BID ADDENDUM NO. 2
ITB/004/16/KL
CITY OF WINTER SPRINGS
WTP NO. 1 WATER QUALITY IMPROVEMENTS

March 7, 2016

This addendum sets forth changes and/or information as referenced and is hereby made a part of, and should be attached to, the subject Contract Documents.

TYPICAL PLAN VIEW

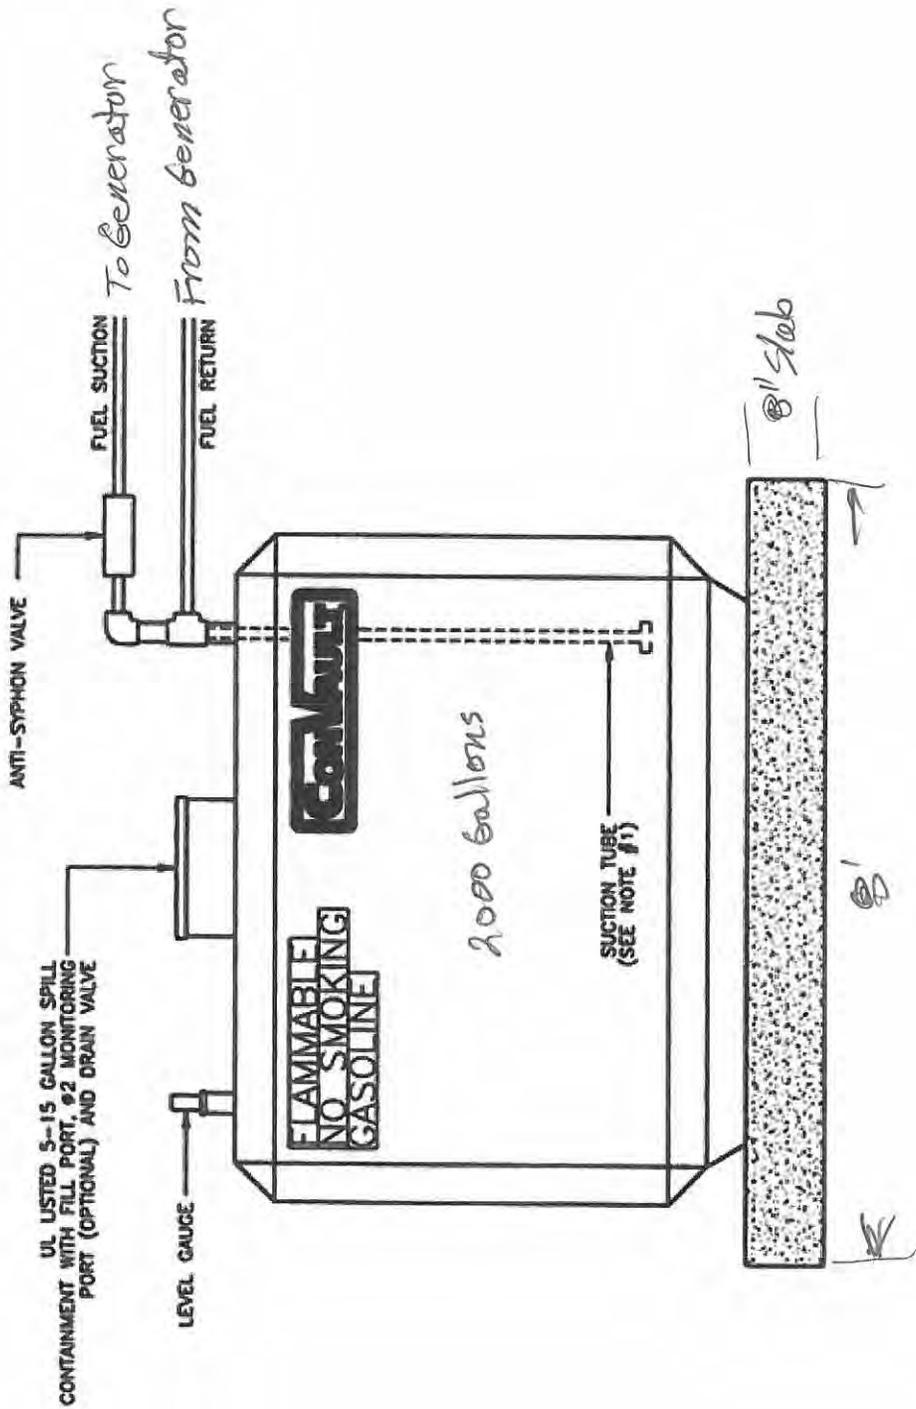
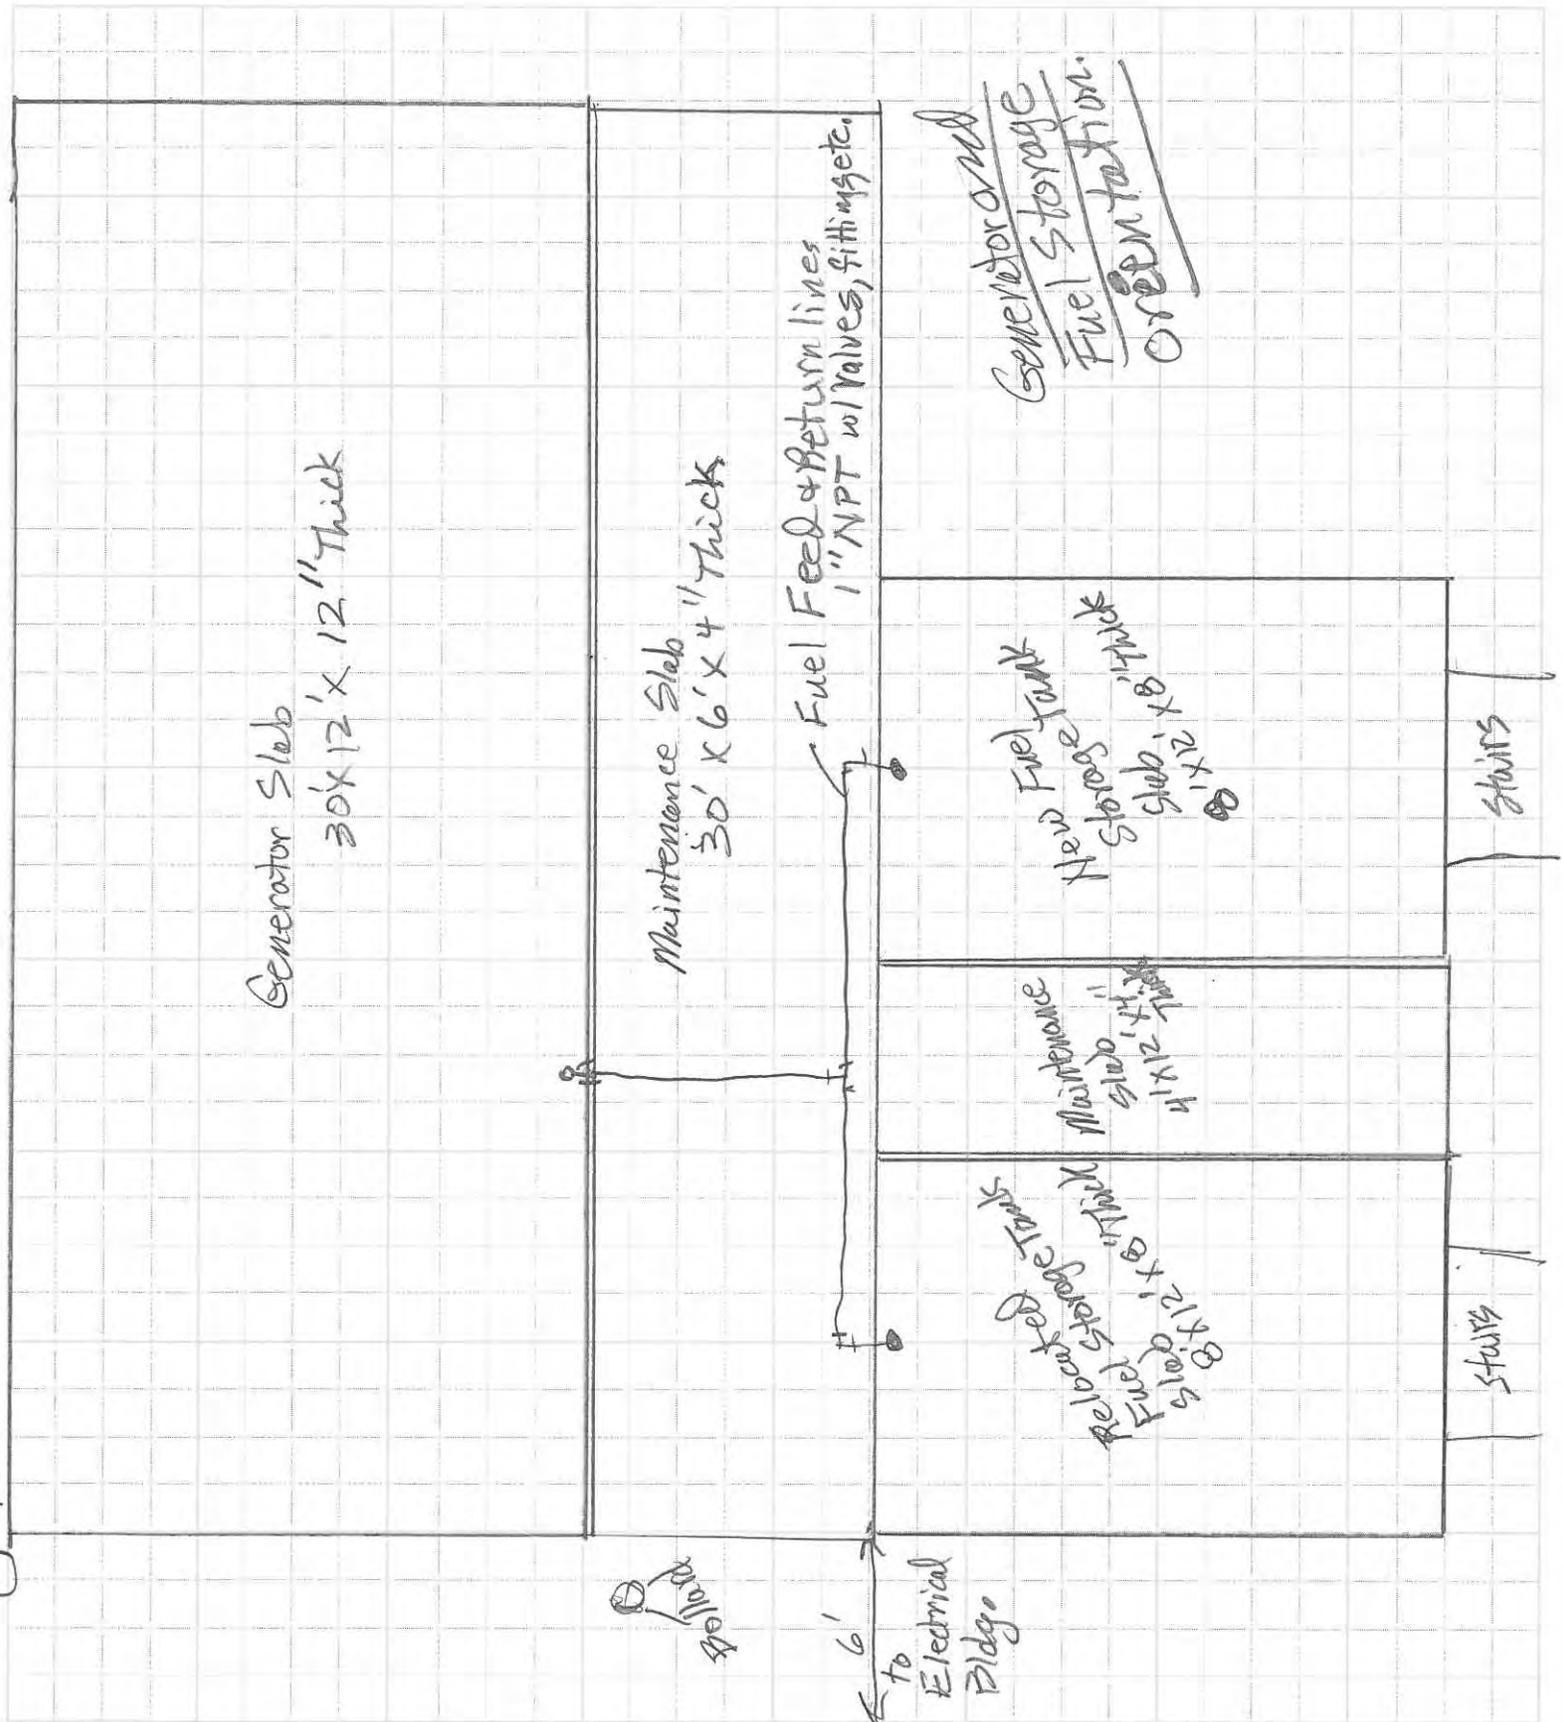
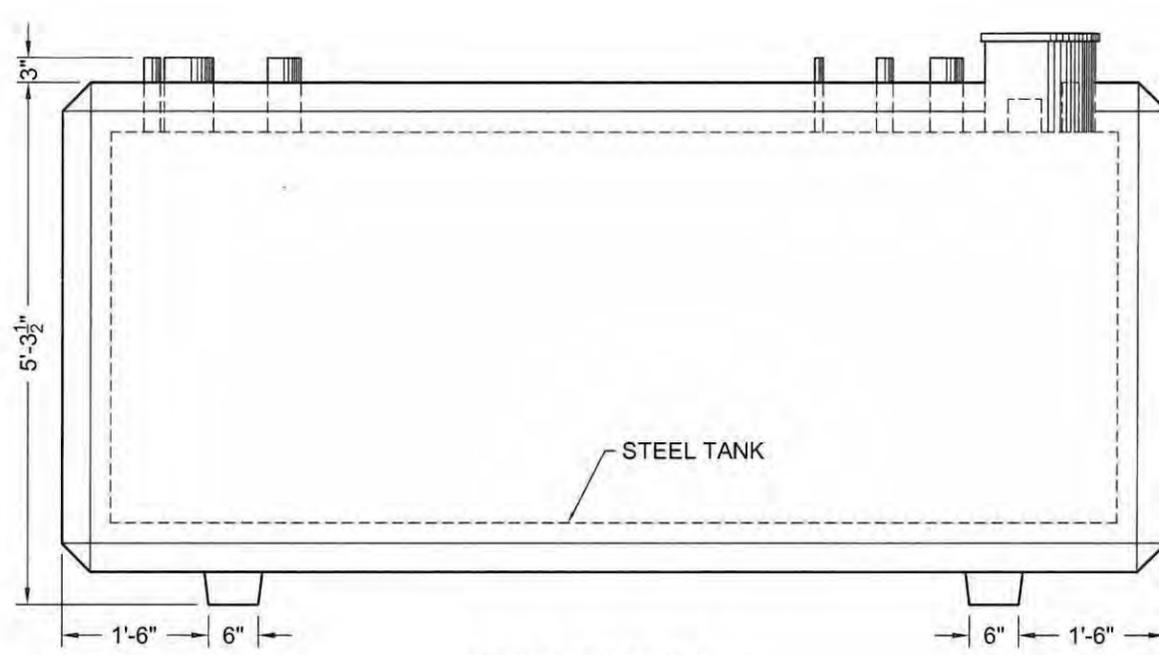
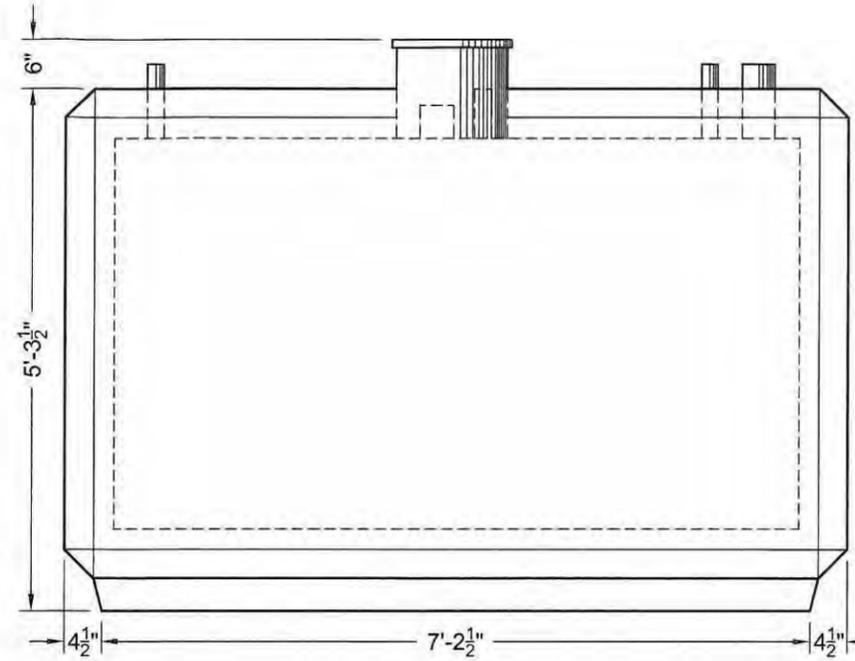
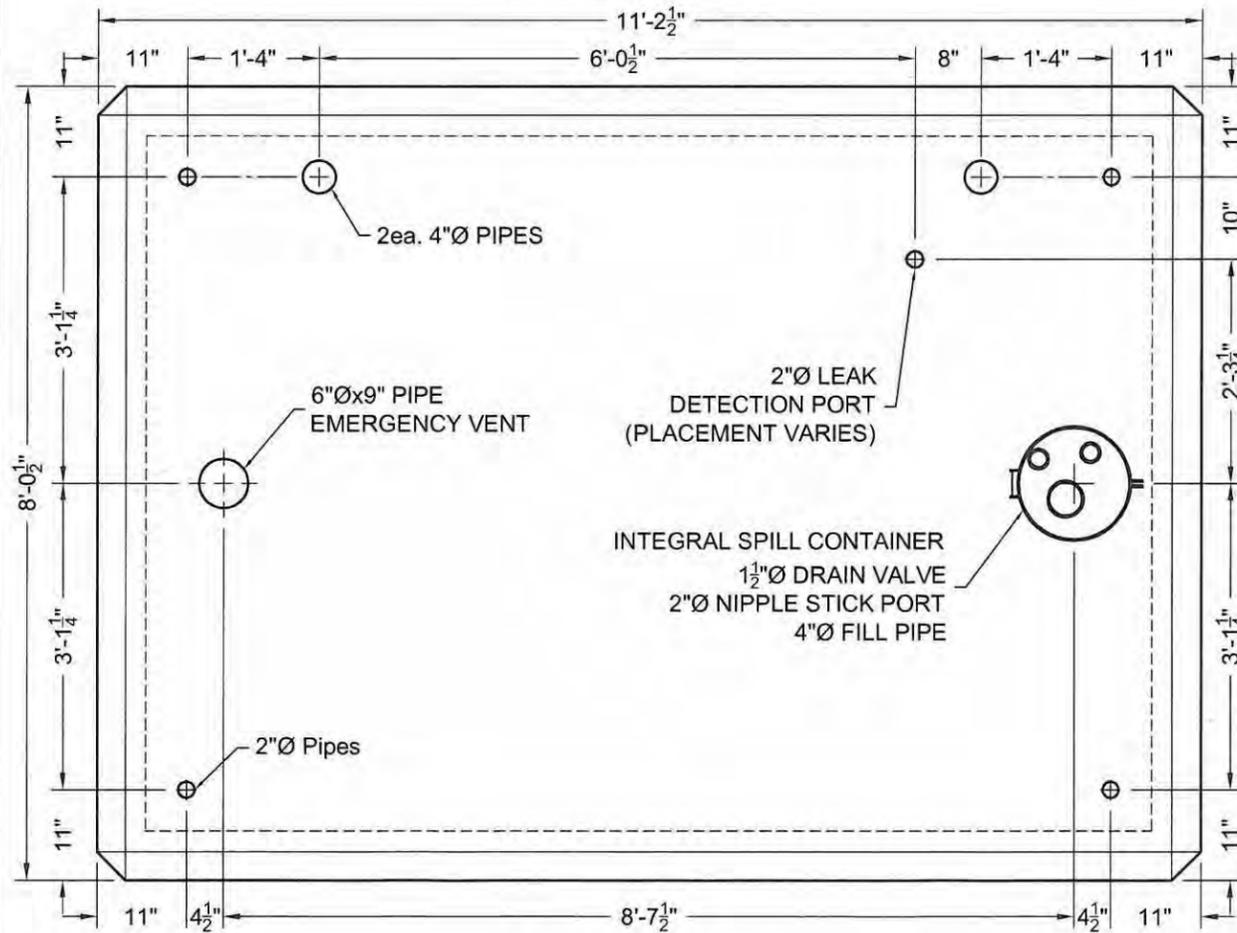
- Comment No.1-5: Please provide slab requirements (structural drawings or details) for the generator and fuel area.
- Response No. 1-5: See attached details for new generator and fuel tank slab requirements.

Comment No. 5-8: Please note Drawing E-16 Generator and Fuel Tanks – Electrical Plan. It would seem that the Generator is sitting on a concrete pad of some type. Please confirm that a concrete pad is required and provide details of size, location with details of rebar and specified concrete type.

Comment No. 5-9: Please note Drawing E-16 Generator and Fuel Tanks – Electrical Plan. It would seem that the Generator Fuel tanks are sitting on some type of platform. Please confirm that the diesel tanks are sitting on a platform and provide details of what type of platform with detailed drawings on how to construct it.

- Comment No. 15-5: Relocated Generator and Fuel tanks due not have details for concrete pads. Reference sheets E-4, E-16.
- Response No. 15-5: See attached details for new generator and fuel tank slab requirements.

Response No. 5-9: See attached details for new generator and fuel tank slab requirements.

Concrete Slab
 8" Thick
 #4 Rebars @ 12" OC. EWEEF;
 For 2000 Gallon Tank Slab is 8' x 12'

#4 Bars EW EF @ 12" O.C.

ELECTRICAL DEMOLITION SITE PLAN

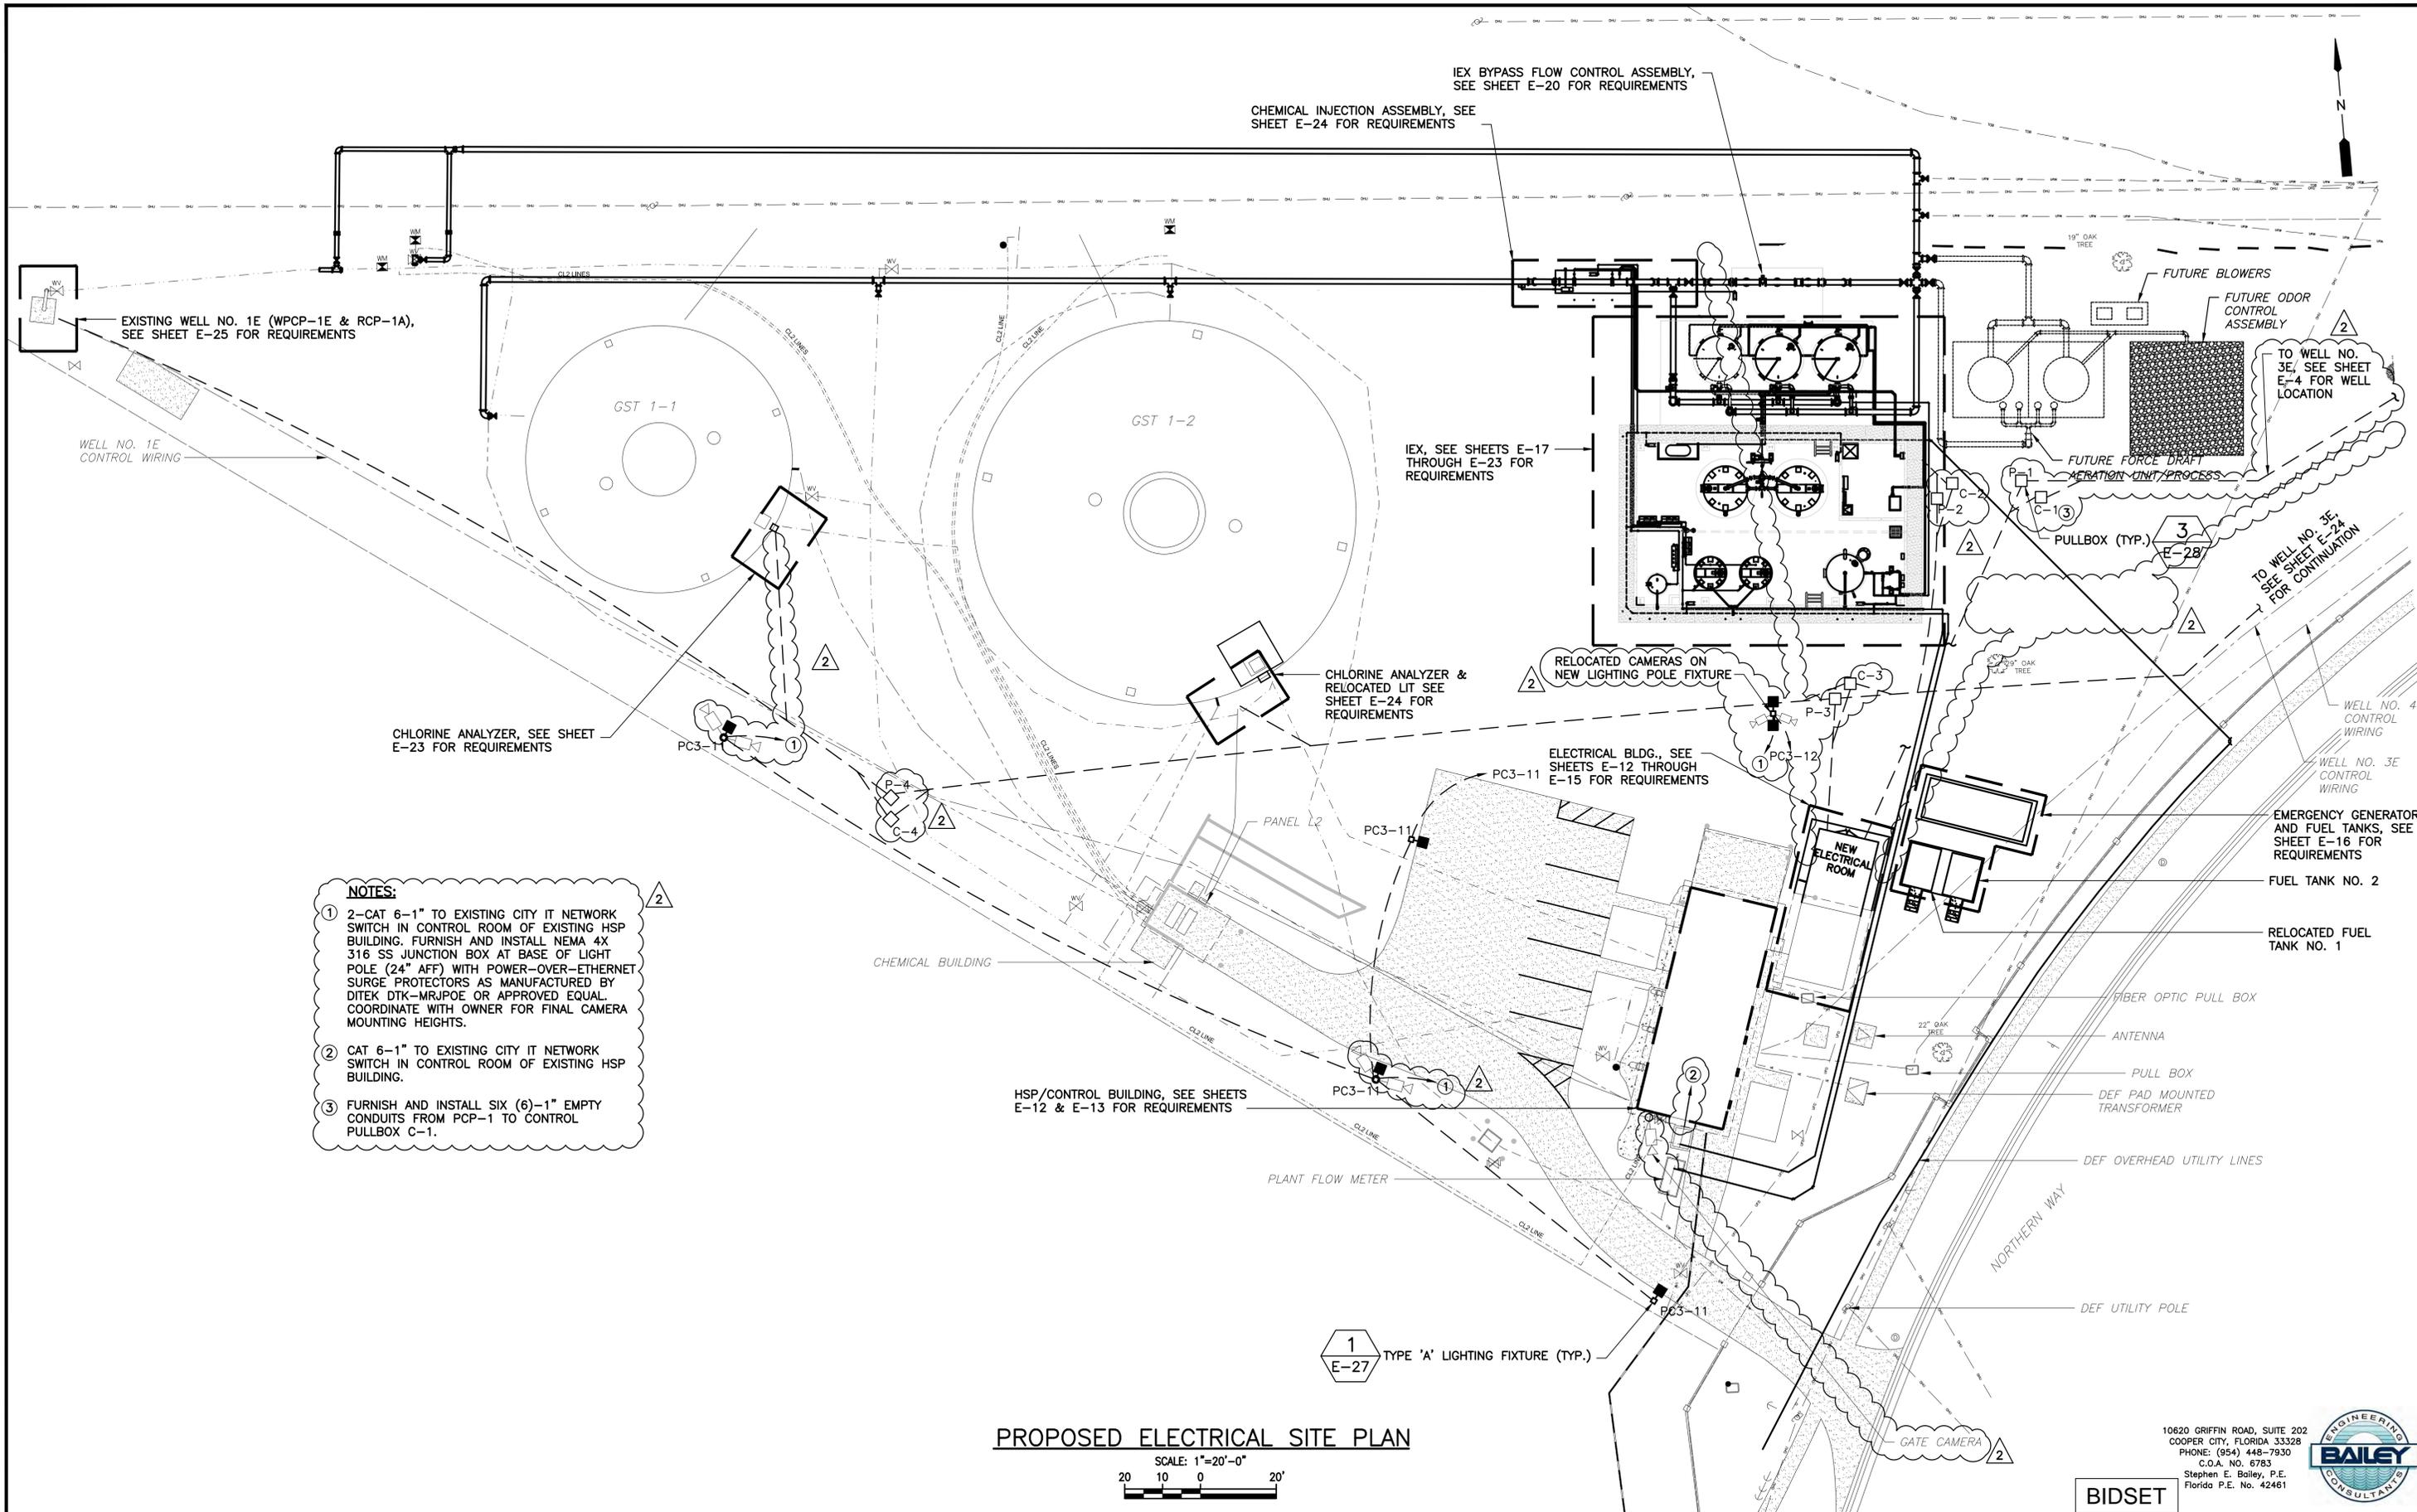
Comment No. 3-7: E-5 & E-6 call for removal and replacement of the DEF electrical service and meter. Will the City pay for all the fees incurred by DEF? If this is to be the responsibility of the Contractor, please include a DEF Allowance.

Response No. 3-7: See attached response provided by Electrical Engineer.
